## IMPORTANT SAFETY NOTICE

**PRODUCT AFFECTED:** Type G105, G106 & G107 Back Check Valves  
Shipped During August, September & October, 2001

**INCORRECT ASSEMBLY  
 G105, G106 OR G107  
 BACK CHECK VALVE**

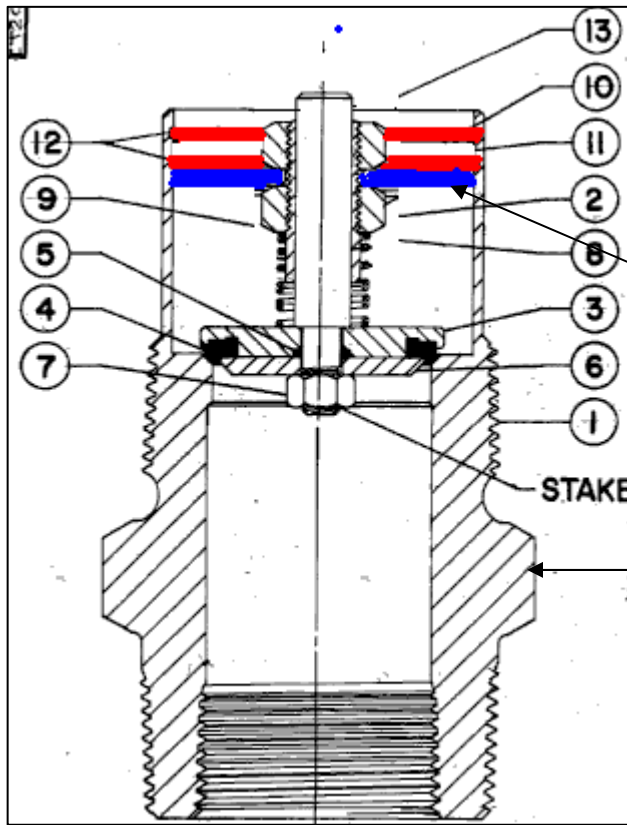
**PROBLEM:** Fisher Controls found an assembly problem with the G105, G106 and G107 steel Back Check Valves which could hinder the guiding and prevent the proper seating of the disc. **This improper seating is a potential safety problem, which could cause a fire and/or explosion resulting in property damage or personal injury if there were a hose or piping failure that required the back check to shutoff the flow of product.**

Guide (11) installed below lower retaining ring (12). Guide (11) should be installed between retaining rings (12)

- (1) **Check your inventory** of G105, G106, and G107 Back Check Valves for manufacturing stamped dates of 8-01, 9-01 or 10-01, or that have their box labels dated in August, September or October 2001.
- (2) **Return for replacement any inventory** that is found with these manufacturing dates to your Fisher Distributor.
- (3) **Locate any product that is installed.** Contact your Fisher Distributor to work out the details to replace the installed valve.
